RE: Volcano Cliffs Subdivision Lot 7 Block 8 Unit 18 6509 Canavio Pl NW Grading and Drainage Plan **Engineers Stamp Date 1/30/17 (D10D003O7)**

GRADING AND DRAINAGE PLAN

LOT 7, BLOCK & JUNIT 18, VCS

GRADING AND DRAINAGE PLAN
LOT 7, BLOCK & UNIT 18, VCS
ADDRESS: 6509 Canavio PL NW

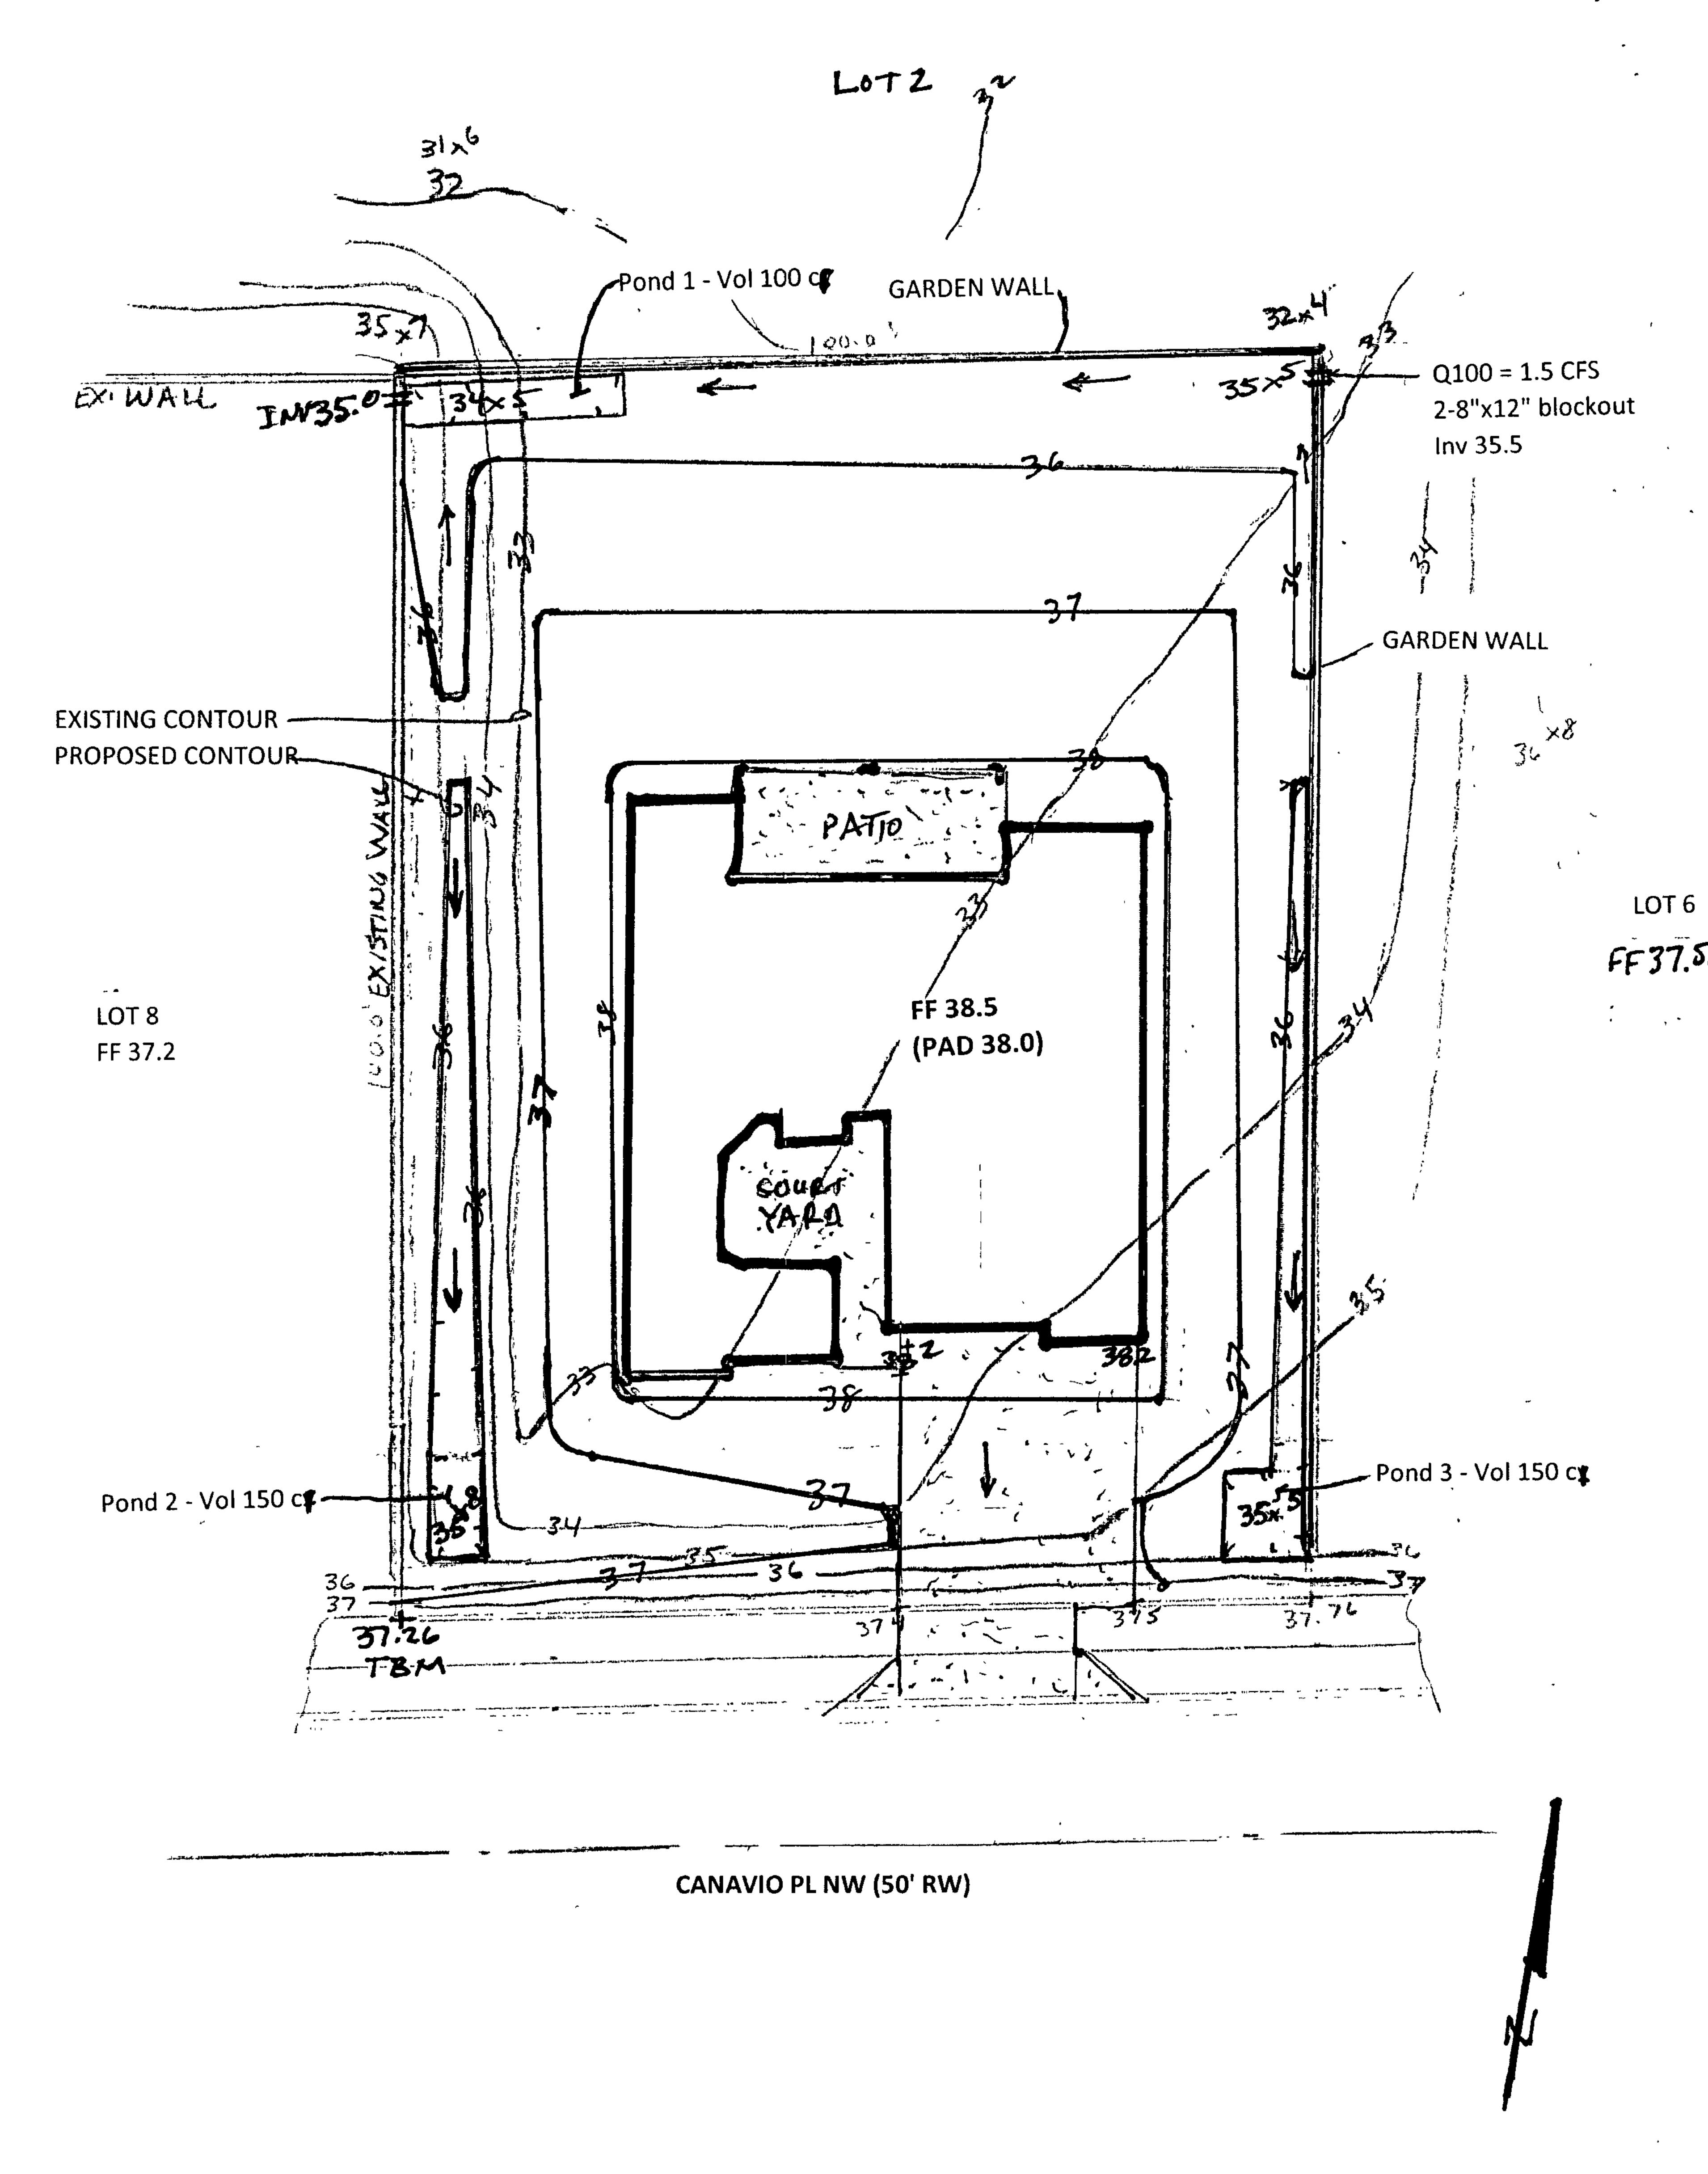
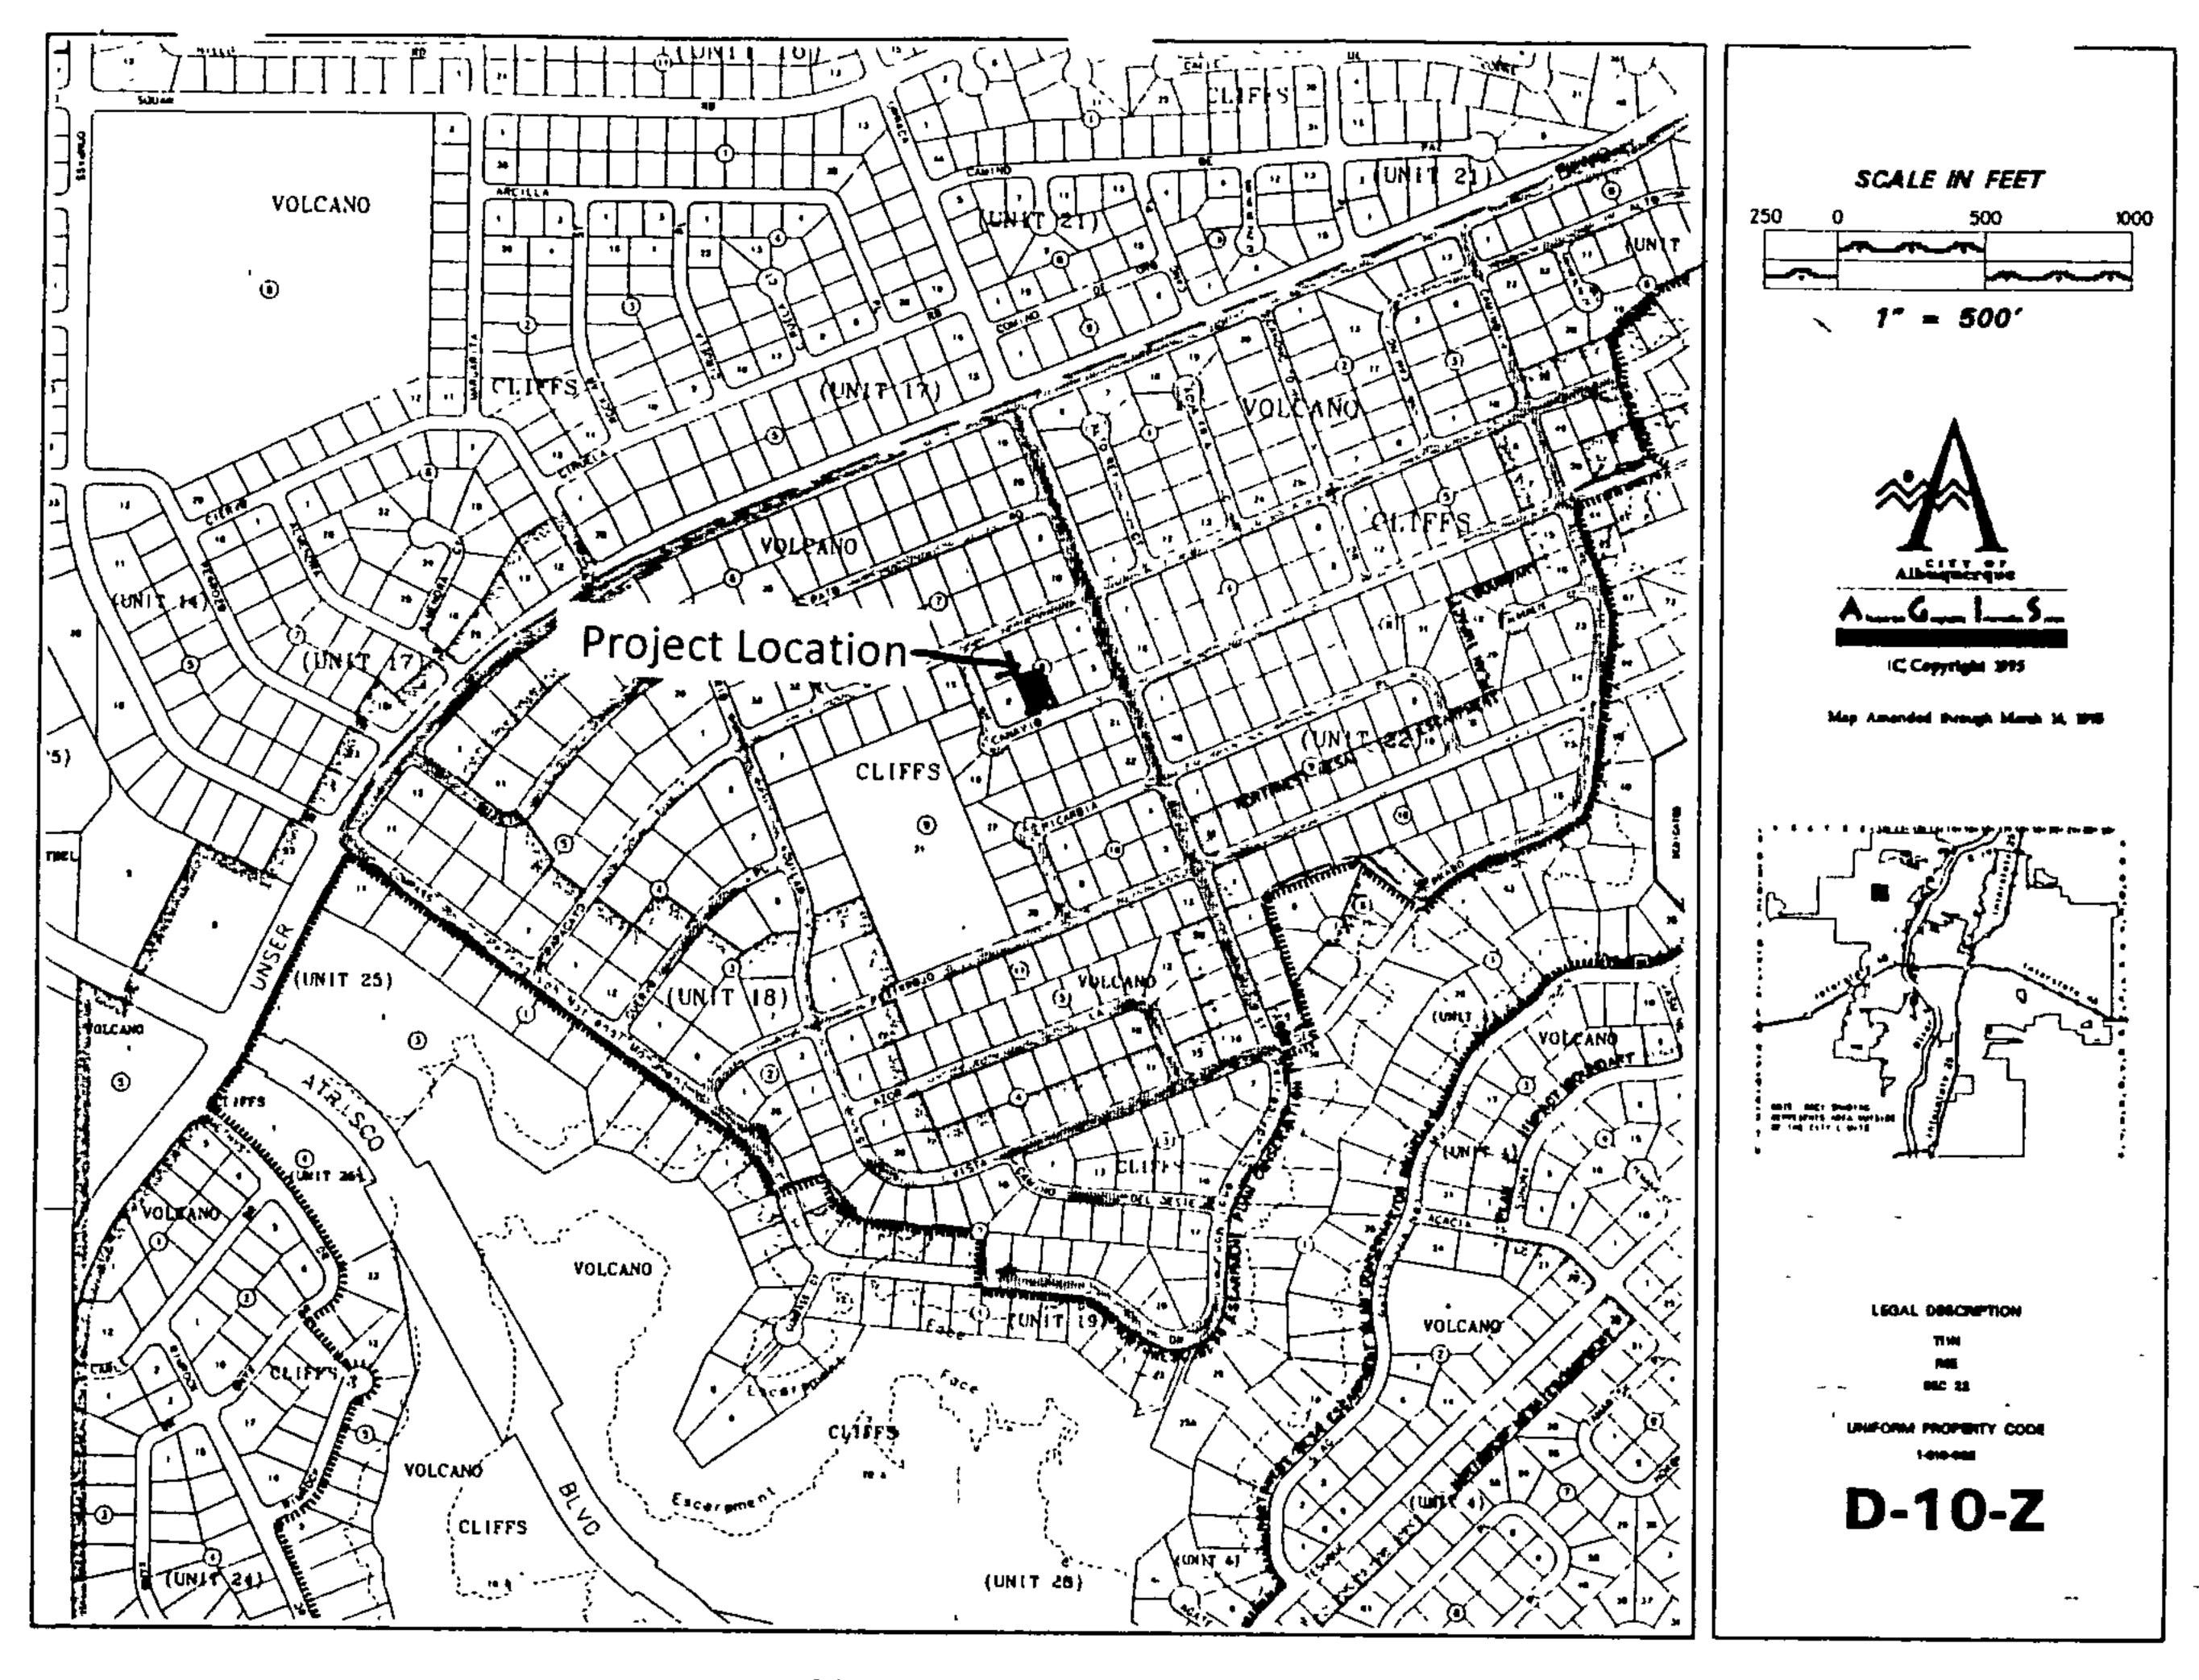
Based upon the information provided in your submittal received 1/17/17, the above referenced Grading and Drainage plan dated 1/17/17 cannot be approved for Grading Permit until the following comments are addressed:

- Provide a note stating that future garden walls require a separate permit and this plan should be used for their placement.
- Provide a statement that a pad certification is required before a building permit is given.
